**Article 16 (1)(a)(i) Further Information**

**Waste Licence Review No. W0140-04**

Nurendale Ltd T/a PANDA Waste Services,  
Rathdrinagh,  
Beauparc,  
Navan,  
Co. Meath.

**November 2011**

SCALE	DRAWING No.	REV.
1:600 A3	3	C

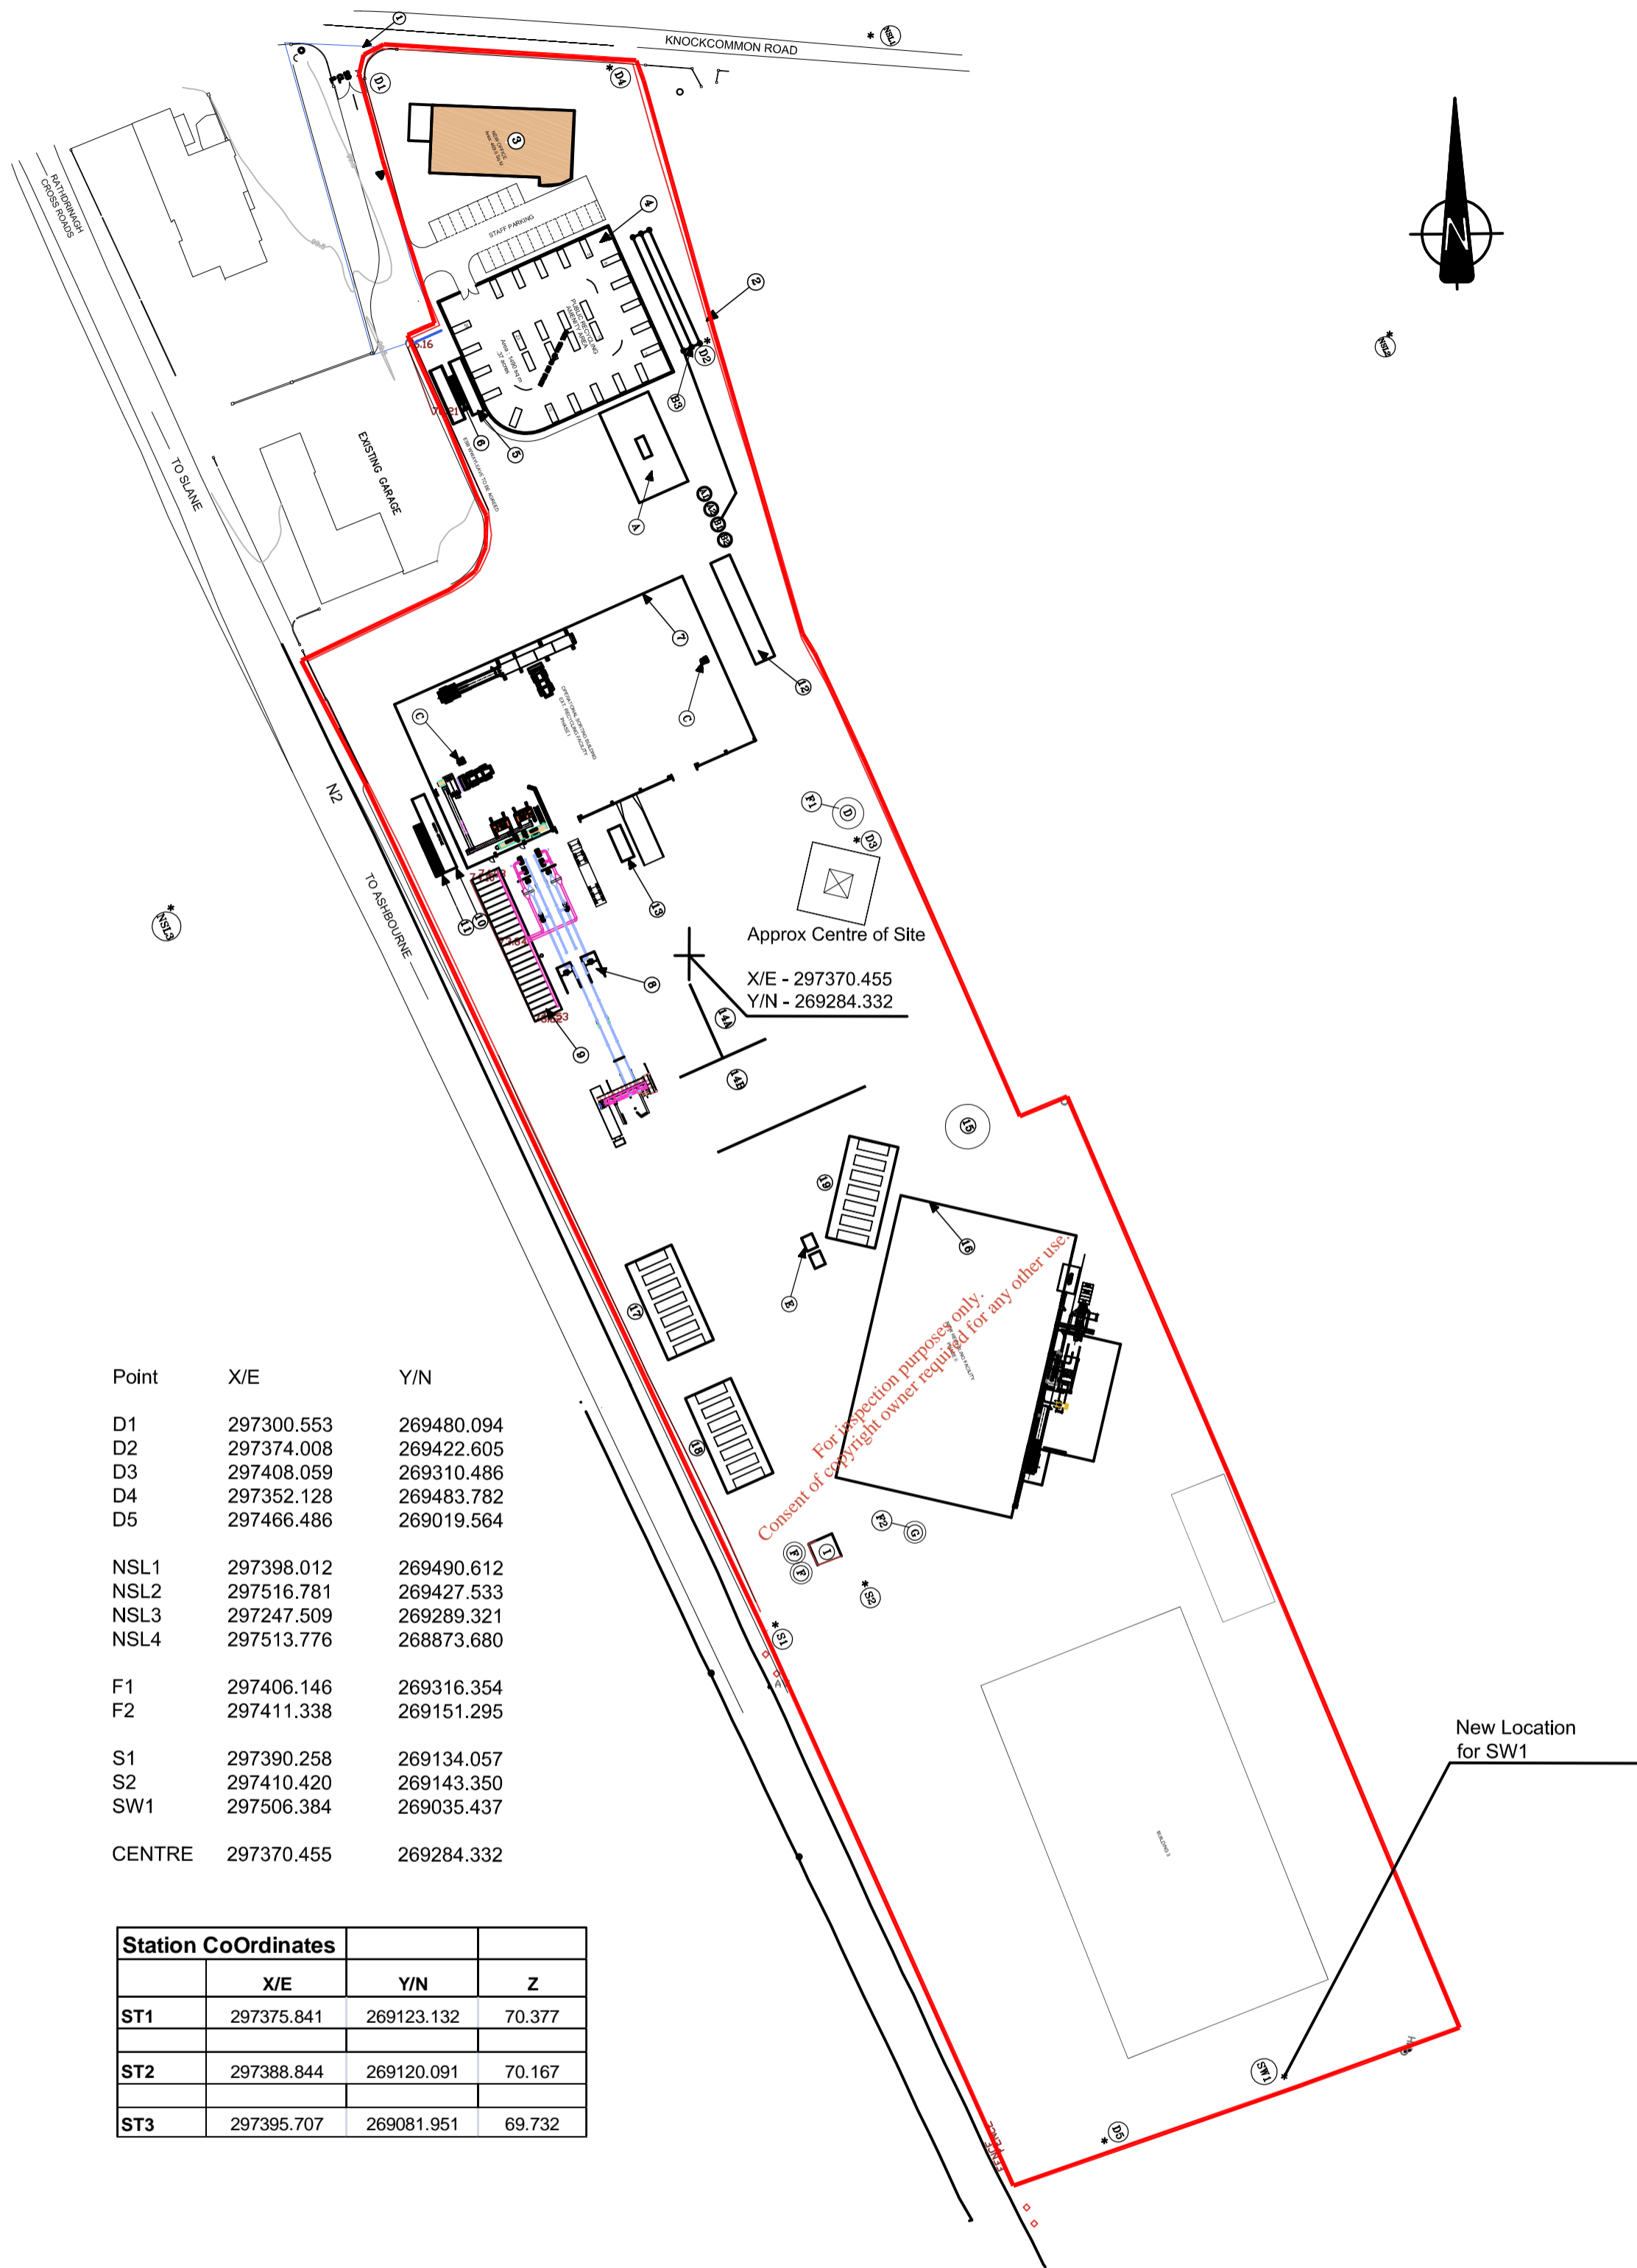
1. Section 1.2, Appendix 2 of the application states that an emergency flare burns the surplus biogas from the biological treatment facility. Additional information supplied to the Agency on 8 September 2011 states that biogas will be fed into three gas powered electricity generators and the associated air emission points A2-3, A2-4 and A2-5 have been identified on drawing number 3 revision C at the CHP unit. The dispersion modeling assessment supplied to the Agency on 21 April 2011 also states that A3, A4 and A5 are the emission points from the CHP gas engines.

- Confirm whether air emissions will be generated from three gas engines and a gas flare as part of the overall operation of the CHP plant.

- Update all associated drawings with the correct number of air emission reference points (including the gas flare).

The reference to three gas powered generators in the information supplied on the 8<sup>th</sup> September was an error. There will be two (2 No.) gas powered generators (gas engines) and one (1No) gas flare. The two gas engines and the flare will not run concurrently. The flare is provided as a backup when the engines are not available to combust the gas, i.e. during commissioning.

Drawing No 3 Rev C, dated 6<sup>th</sup> May 2011 shows the relevant emission points: - A2-5 for gas engine No 1, A2-4 for gas engine No. 2 and A2-3 for the Gas Flare. A copy of the Drawing is enclosed.

The correct references for the emission points are shown on Drawing No 3 RevC.
